Access Compliance Report

Public Rights-of-Way

(Curb Ramps)

Intersection ID: 17502	Main Street: HEATHERDALE_CT	Cross Street: PINEY GROVE_RD	Location: SE
ADA ID: 1C7F0296BB71	Ramp Type: PerpDiag	Initial Pass/Fail: Fail	Overall Compliance: No
Severity Score: 10			
Codes/Mitigation Info/Possible Solution		Field Measurements/Component Compliance

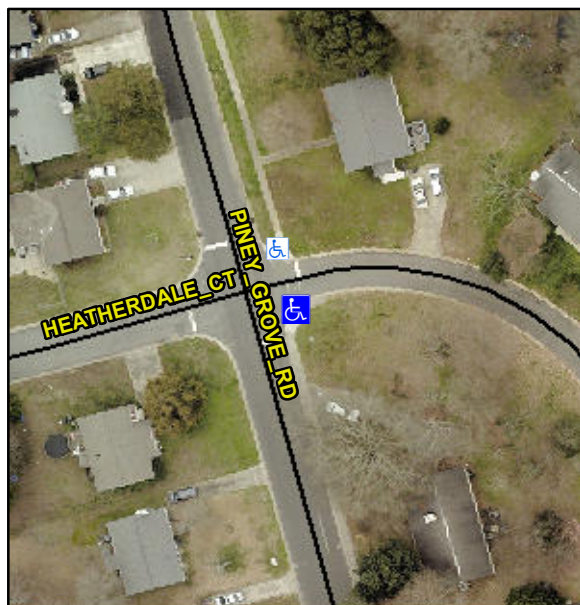
R304.5.1, R304.5.3

Compliance	Description	Data	Compliance	Description	Data
N/A	Ramp Length (in)	65.0	Yes	Ramp Slope (%)	5.5
No	Ramp Width (in)	47.0	No	Ramp XSlope (%)	2.4
N/A	Flare Type LT	N/A	N/A	Flare Type RT	N/A
N/A	Flare Slope LT (%)	N/A	N/A	Flare Slope RT (%)	N/A
N/A	Flare Traversable LT?	N/A	N/A	Flare Traversable RT?	N/A
N/A	Landing Length (in)	N/A	N/A	DWS Provided?	N/A
N/A	Landing Width (in)	N/A	N/A	DWS Contrast?	N/A
N/A	Landing Slope (%)	N/A	N/A	DWS Length (in)	N/A
N/A	Landing X Slope (%)	N/A	N/A	DWS Full Width?	N/A
N/A	Landing Curb? (Y/N)	N/A	N/A	DWS Offset (in)	N/A
N/A	Shared Landing?	N/A			
N/A	Gutter Ponding?	N/A	N/A	Gutter Slope (%)	N/A
N/A	Gutter Lip Ht (in)	N/A	N/A	Gutter X Slope (%)	N/A
N/A	Painted X Walk1?	No	N/A	Painted X Walk2?	No
	X Walk 1 Direction	To N		X Walk 2 Direction	To W
N/A	X Walk 1 Width (in)	N/A	N/A	X Walk 2 Width (in)	N/A
	X Walk 1 Slope (%)	3.6		X Walk 2 Slope (%)	0.9
	X Walk 1 X Slope (%)	1.7		X Walk 2 X Slope (%)	2.8

Remove & Replace Curb Ramp With Two New Directional Ramps or Equivalent.
